AN ORDINANCE WAIVING THE SIDEWALK REQUIREMENTS OF SECTION 15-09.003 OF THE CITY OF ATLANTA CODE OF ORDINANCES FOR SUBDIVISION APPLICATION SD-12-011 (394 MCWILLIAMS AVENUE, SE); TO PROVIDE THAT IN LIEU OF THE REQUIRED SIDEWALKS AT THE SUBDIVISION SITE, THE DEVELOPER OF THE SUBDIVISION SHALL CONSTRUCT SIDEWALKS OF EQUAL OR GREATER LENGTH ALONG THE WEST SIDE OF JOSEPH AVENUE FROM THE END OF EXISTING SIDEWALK TO PORTLAND AVENUE; AND FOR OTHER PURPOSES.

RE: Sidewalk Waiver Request - 394 McWilliams Avenue S.E. (SD-12-11)

SUBJECT: **Sidewalk waiver request for 394 McWilliams Avenue, SE (SD-12-011)**

EXHIBIT 'D'

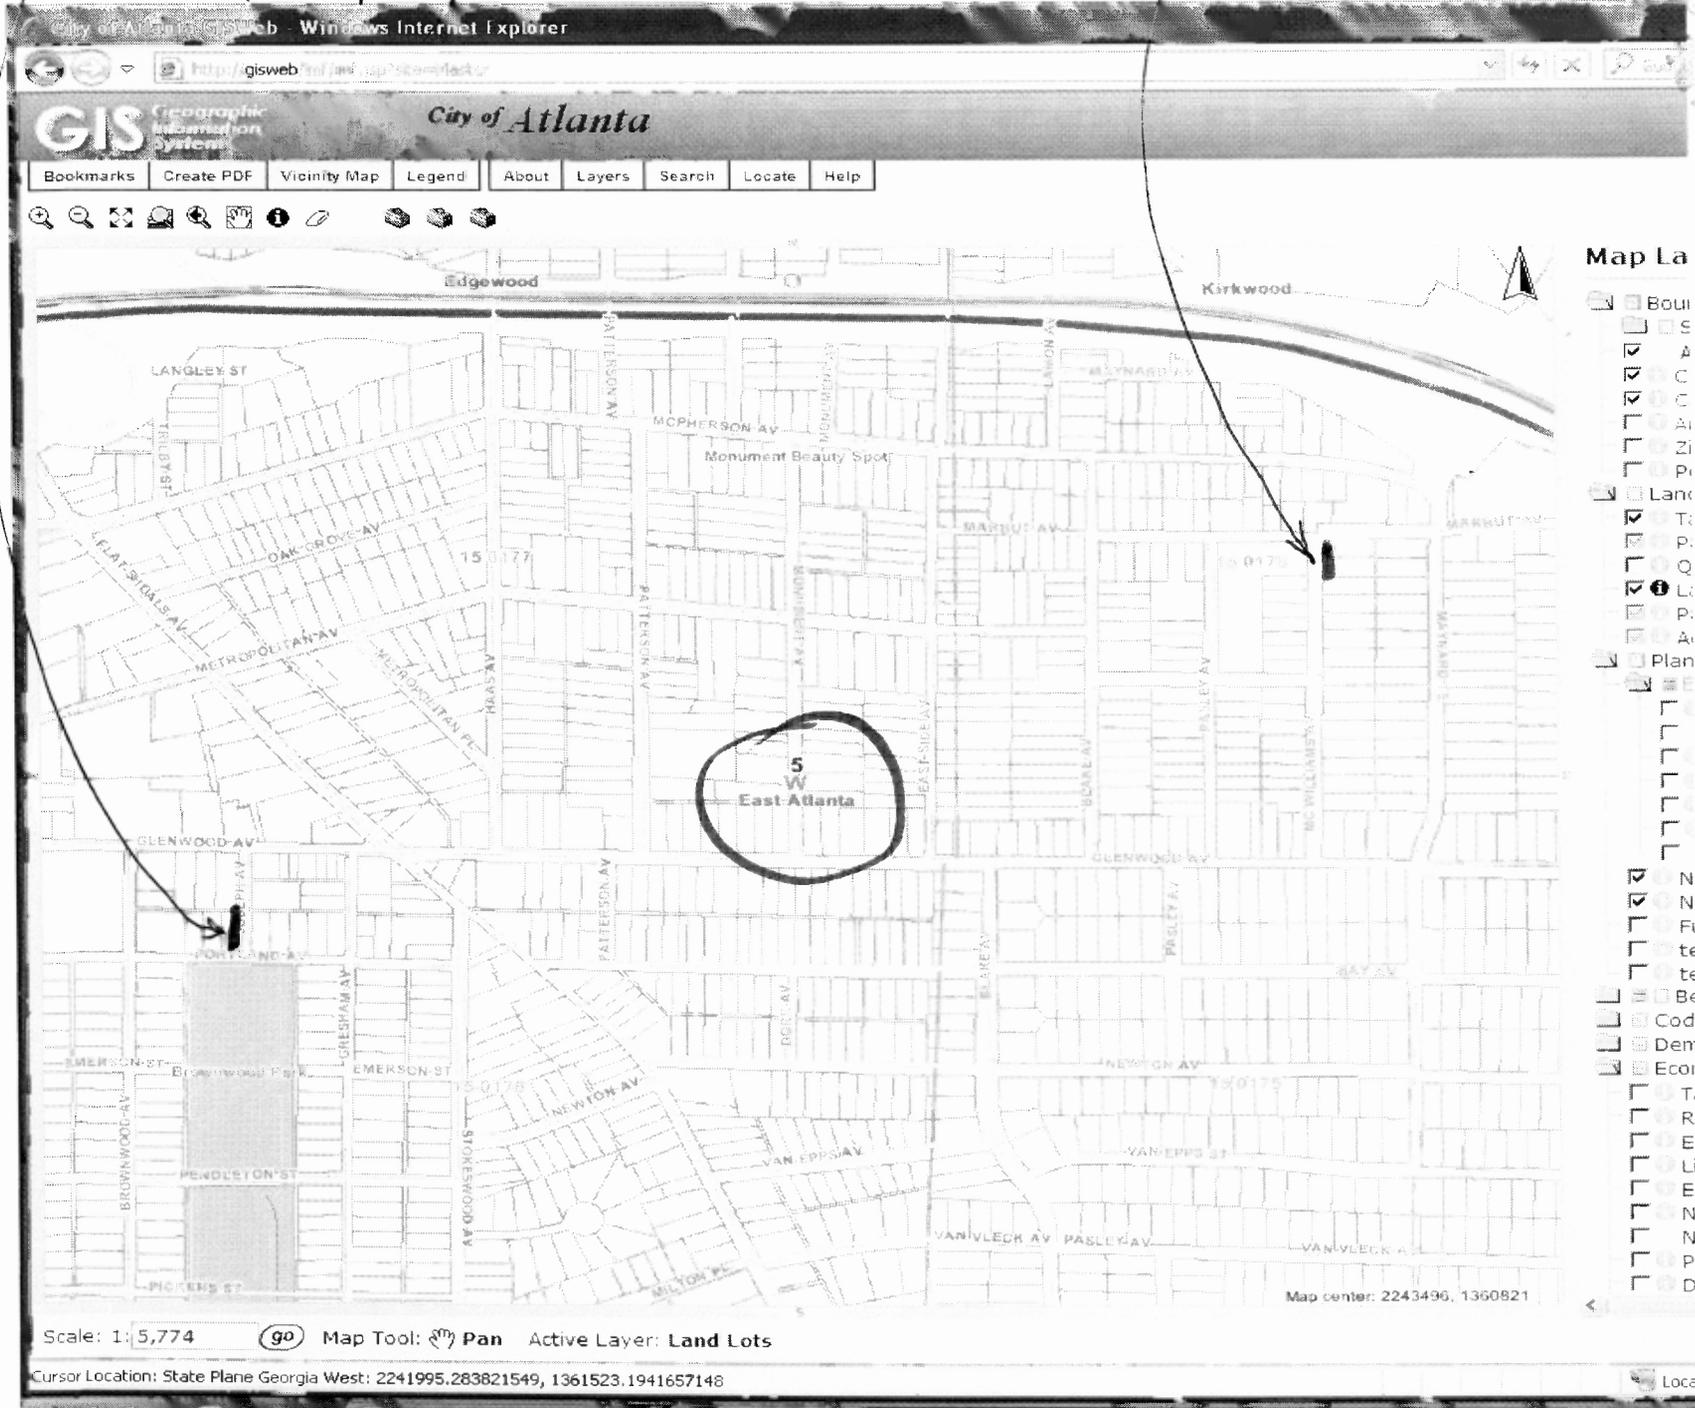
In lieu of installing the 140.4 feet of sidewalk required at this subdivision, the applicant has proposed to install an equivalent sidewalk along the west side of Joseph Avenue from the end of the existing sidewalk to Portland Avenue, a distance of 168 feet. The department approves of the proposed alternative location which will provide for greater connectivity and pedestrian safety than the subject property. Upon approved Council legislation, the applicant is required to submit construction plans for approval and to obtain a permit from the Department of Public Works prior to installation of the sidewalks. Such plans shall include all improvements to meet the Americans with Disability Act (ADA) requirements.

The Office of Planning has received a request to construct sidewalks for the above referenced land subdivision application at an alternate location. The length of the sidewalk required to be built is at the subject location is 140.4 feet. The proposed alternative location is along the west side of Joseph Avenue, from the end of the existing sidewalk to the north side of Portland Avenue, a length of 168 feet.

My office has reviewed the subdivision application as well as the applicant's proposal for waiver of the sidewalk and staff is of the opinion that the proposed alternate location for the sidewalk is reasonable for the following reasons:

- There is no existing sidewalk at the site location to serve as a connection.
- The alternate proposed location remains within the same Council District, same neighborhood planning unit W and same local neighborhood of East Atlanta.

- Constructing the sidewalks at the alternate proposed location would complete the entire west side of Joseph Avenue between Glenwood Avenue and Portland Avenue with connecting sidewalks.
- Just across the street on Glenwood Avenue, there is existing restaurant and retail space with significant pedestrian traffic.

SECTION 2: The waiver of said requirement for the aforementioned application is conditioned upon the agreement of developer Andrew Levine to construct 168 feet of sidewalks along the west side of Joseph Avenue from the end of existing sidewalks to Portland Avenue, as more fully depicted on Exhibit "D", attached hereto.
